DESIGN <i>RT</i>	DRAWN BY <i>TF</i>	DART AEROSPACE LTD HAWKESBURY, ONTARIO, CANADA	
CHECKED <i>H</i>	APPROVED <i>H</i>	DRAWING NO. DSI 9279	REV. A SHEET 1 OF 2
DATE 04.04.22		TITLE STROBE POWER SUPPLY RELOCATION SCALE NTS	
A	04.04.22	NEW ISSUE

DART SERVICE INSTRUCTION

TO AMEND INSTALLATION DRAWING D350-604 REV. B

REF. CANADIAN STC: SH90-4

VIEW LOOKING OUTBOARD

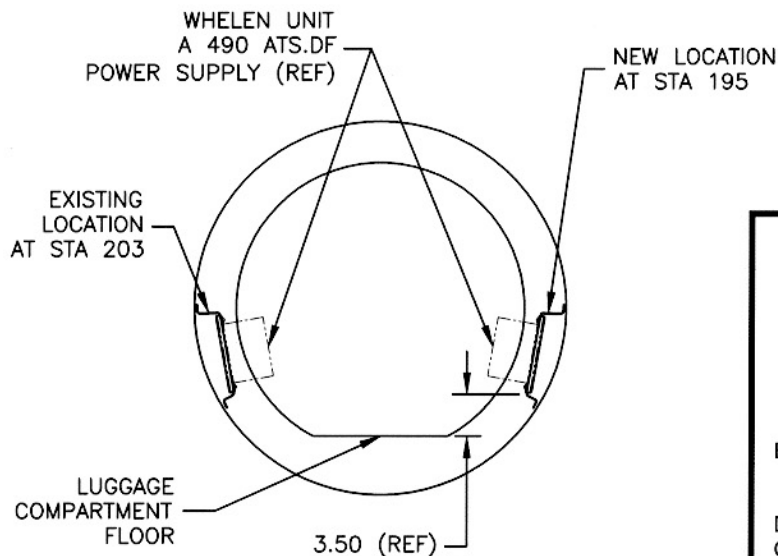
The purpose of this Service Instruction is to allow for relocation of power supply for the anti-collision strobe light so that the D350-604-041 Rear Locker Extender can be properly installed in aircraft modified per SB 33.05.

- 1) Open luggage compartment and remove protective panels.
- 2) Position and transfer Ø0.129" (3.25mm) holes from D3246-041 Mounting Bracket to skin at (LH) side of the fuselage STA 195 as shown in the sketch. Install D3246-041 Mounting Bracket using (8) 21215 DC 24.07J/MS20470AD4 rivets

- 3) Disconnect tail boom electrical cables LX10E, LX11NE and LX12E from WHELEN A 490 ATS.DF Unit.
- 4) Remove WHELEN A 490 ATS.DF Unit from the original location at STA 203, by removing (4) 22272 BC 040.008L screws.

- 5) Install D350-604-041 Rear Locker Extender per Dart Installation Instruction D350-604.
- 6) Install WHELEN A 490 ATS.DF Unit to D3246-041 Mounting Bracket using (4) MS27039-1-07 Screws And (4) AN960JD10 Washers.

- 7) Re-route Cables LX10E, LX11NE and LX12E from the (RH) side to the (LH) side of the tail boom and re-connect to WHELEN A 490 ATS.DF Unit.
- 8) Re-connect Cables LX10E, LX11NE and LX12E
